AIRPORT IMPROVEMENTS

HARTNESS STATE AIRPORT
SPRINGFIELD, VERMONT

A.I.P. PROJECT NO. 3-50-0016-01
A.I.R. 03-2044

AS BUILT PLANS
I hereby certify that all the construction required by this set of drawings has been accomplished as indicated herein.
By Paul Jensen Project Engineer
Date 12-2-88

RELOCATED THRESHOLD MARKING
N.T.S.

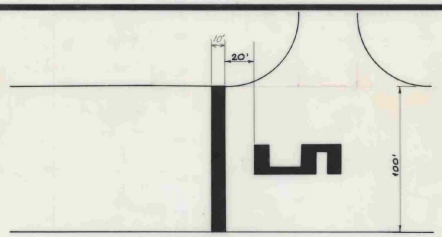
1. EIGHT TEMPORARY THRESHOLD LIGHTS* WERE ~~ARE TO~~ BE INSTALLED AS SHOWN.
2. CONTRACTOR ~~TO~~ INSTALL LIGHTS & SPLICE INTO EXISTING RUNWAY LIGHTING CIRCUIT. LIGHTS TO HAVE 180° GREEN/180° RED LENS. LIGHTS ARE TO BE STAKE MOUNTED.

3. THE CARE & MAINTENANCE OF THE LIGHTS ~~SHALL BE~~ THE RESPONSIBILITY OF THE CONTRACTOR DURING THE CONSTRUCTION PHASE. WERE
4. THE AIRPORT* ~~SHALL~~ RETAIN POSSESSION OF THE LIGHTS AFTER COMPLETION OF THE PROJECT. (*AGENCY OF TRANSPORTATION-MAINTENANCE DIVISION.)

5. THE COST OF THE TEMPORARY LIGHTS IS NOT A SEPARATE PAY ITEM. THIS WORK IS NECESSARY & INCIDENTAL TO THE COST OF THE PROJECT.
* LIGHTS ~~SHALL BE~~ MEDIUM INTENSITY THRESHOLD LIGHTS CONFORMING TO FAA SPEC. L-861E, SEE DETAIL SHEET 6 OF 26 WERE

6. THE TEMPORARY RELOCATED THRESHOLD LIGHTS ~~SHALL BE~~ REMOVED AND THE SYSTEM RETURNED TO ITS ORIGINAL CONDITION AFTER COMPLETION OF THE WORK.
7. TEMPORARY RUNWAY MARKING (R/W 5 DISPLACEMENT) ~~MAY BE~~ STRIATED (ALTERNATE 6" PAINTED/6" UNPAINTED) TO FACILITATE REMOVAL. WAS

8. TEMPORARY MARKING ~~SHALL BE~~ COMPLETELY OBLITERATED BY GRINDING TO THE SATISFACTION OF THE ENGINEER. AFTER COMPLETION OF THE WORK. WERE
9. TEMPORARY MARKINGS ~~ARE TO BE~~ PAID FOR UNDER ITEM 816.10 "RUNWAY AND TAXIWAY PAINTING." WERE

10. THE CONTRACTOR ~~SHALL~~ REMOVE THE BULBS DURING THE CONSTRUCTION PHASE IN THE EXISTING RUNWAY LIGHTS FROM THE THRESHOLD OF RUNWAY 5 TO THE TEMPORARY THRESHOLD AND REPLACE PRIOR TO COMPLETION OF THE PROJECT. D
11. PRIOR TO THE RELOCATION OF RUNWAY 5, THE AGENCY OF TRANSPORTATION - OPERATION DIVISION SHALL HAVE TO COORDINATE THE SHUTDOWN OF THE VASI AND REILS ON RUNWAY 5 - CONTACT ANE 460 - PAA FACILITIES MAINTENANCE
12. NUMERAL (5) AND THRESHOLD BAR ~~ARE TO BE~~ WHITE. TEMPERARY MARKING TO CONFORM TO ITEM 816.10 WERE
CHEVRONS TO BE YELLOW
13. LIGHTED BARRICADES ~~ARE TO BE~~ PLACED TO WARN AIRCRAFT AND GROUND VEHICLES OF CONSTRUCTION AREA, ~~AS SHOWN~~ OR AS DIRECTED BY THE ENGINEER. THIS IS NOT A SEPARATE PAY ITEM. WERE WAS
14. WASTE AREA ~~TO BE~~ GRADED, TOPSOILED, SEEDED, FERTILIZED AND MULCHED AS ORDERED BY THE ENGINEER. WAS

SITE PLAN

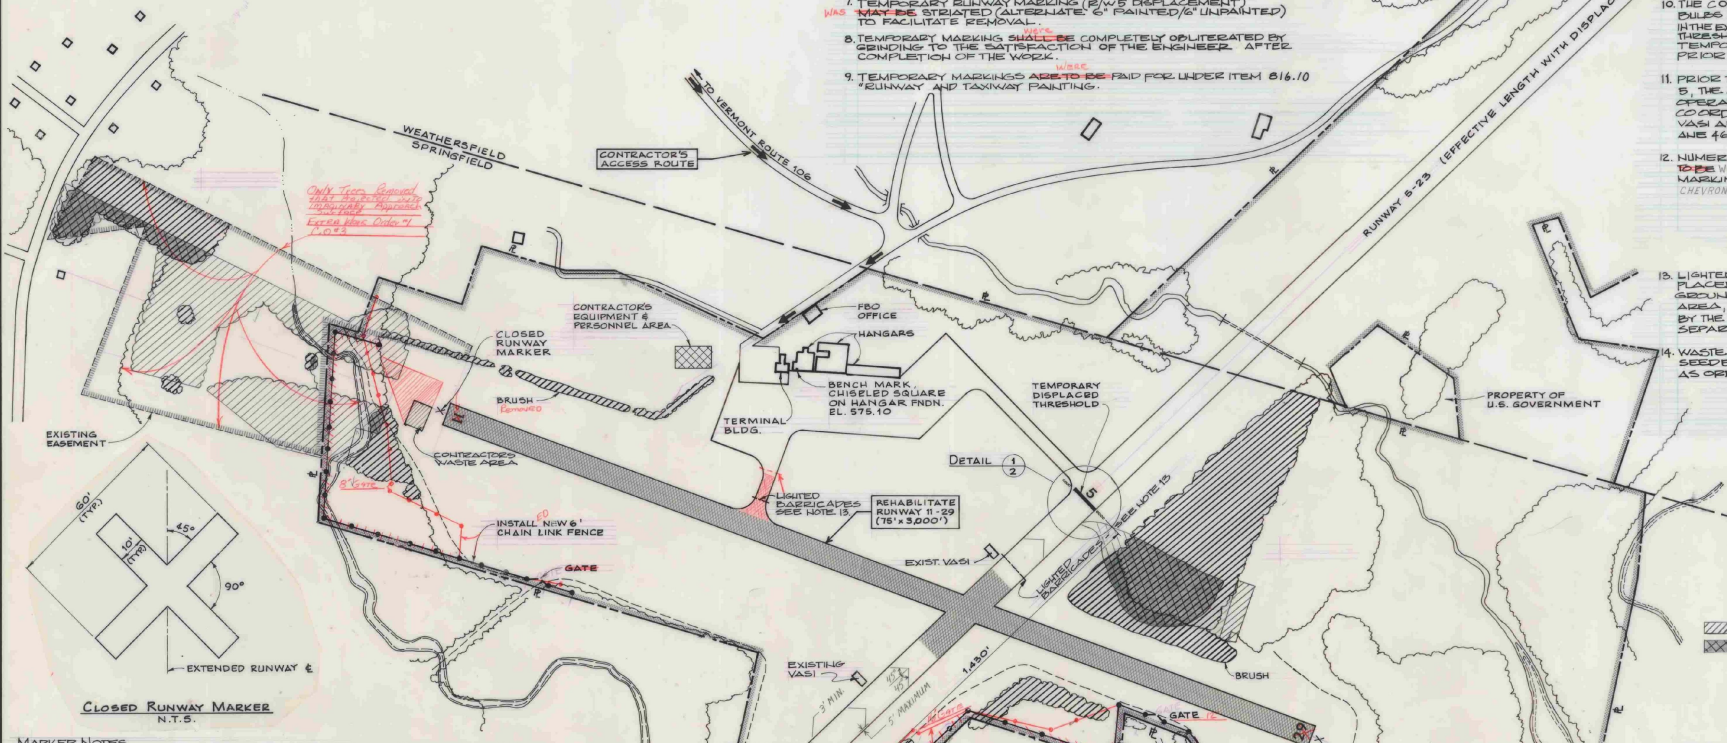
AREA ~~TO BE~~ CLEARED & GRUBBED WAS
AREA TO BE CLEARED BY STATE FORCES

1. CLOSED RUNWAY MARKER ~~TO BE IN~~ PLACED DURING CONSTRUCTION PERIOD AS DIRECTED BY ENGINEER. WAS
2. CLOSED RUNWAY MARKER ~~MAY BE EITHER~~ SNOW FENCE ~~OR PLYWOOD PAINTED YELLOW~~ & SECURELY FASTENED IN PLACE. WAS
3. COST OF PLACING & MAINTAINING THE CLOSED RUNWAY MARKER IS CONSIDERED NECESSARY & INCIDENTAL TO CONSTRUCTION & ~~IS~~ NOT A SEPERATE PAY ITEM. WAS
4. CLOSED RUNWAY MARKER ~~TO BE~~ PLACED OVER R/W 5 NUMERAL DURING R/W 5 RELOCATION

INSTALLATION OF NEW MEDIUM INTENSITY TAXIWAY GUIDANCE SIGNS (BASE MOUNTED) AT TAXIWAYS A & B

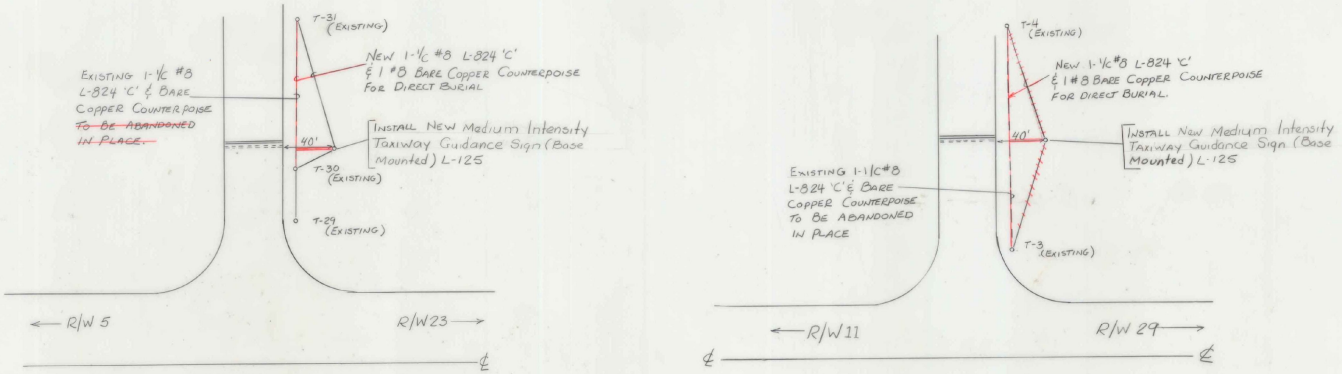
L 108	Cable Trench	160 ~~295~~ LF
L 108	1c #8 L-824 Type 'C', 5KV	160 295 LF
L 108	1c #8 Bare Counterpoise Wire	160 295 LF
L 108	Watertight Connectors, L 823	6 Ea

TYPICAL SECTIONS

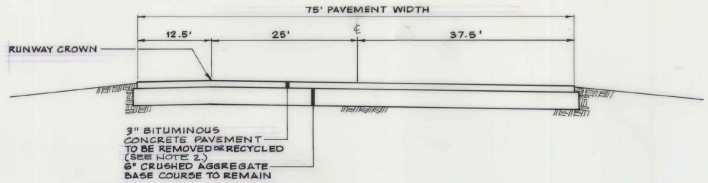
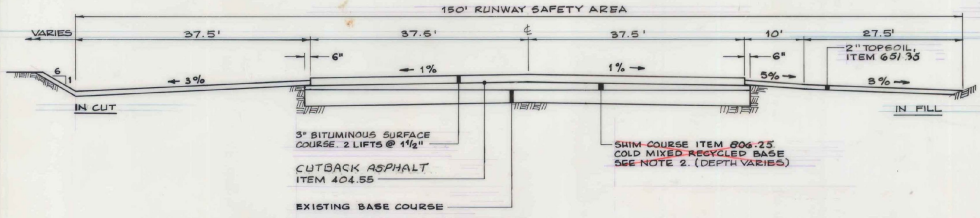
PAY UNIT
ITEM 203.28	EXCAVATION OF SURFACES AND PAVEMENTS	2660 2550 CY
ITEM 302.17	UNCRUSHED AGGREGATE BASE COURSE TYPE 'C' (P-208)	3240 3,000 C.Y.

Seed, Item 651.15 WAS to be applied as directed by Engineer.

Fertilizer, Item 651.18 WAS Formula 10-20-10 to be used with seed, Item 651.10, applied at the rate of 500 lbs/acre.

Agriculture Limestone, Item 651.20 Was To be applied at rate of 2 tons/acre or as directed by Engineer.

Hay mulch, Item 651.25 WAS To be placed on earth slopes at the rate of 2.1 2 tons/acre.

Topsoil, Item 651.35 WAS To be used with seed, item 651.15, as directed by the Engineer.

1. Sub-grade under areas to be paved WAS to be compacted to 100% density as per FAA T-611 (AASHTO T-180).
2. Bituminous tack coat WAS to be applied as per Item 404, Subsection 404.06, Type I first Application using RC-250.
3. Existing bituminous conc.pvmt. from Runway 11-29 to be pulverized and blended to form a cold mixed recycled base (shim) course Item 806.25 for the runway rehabilitation.
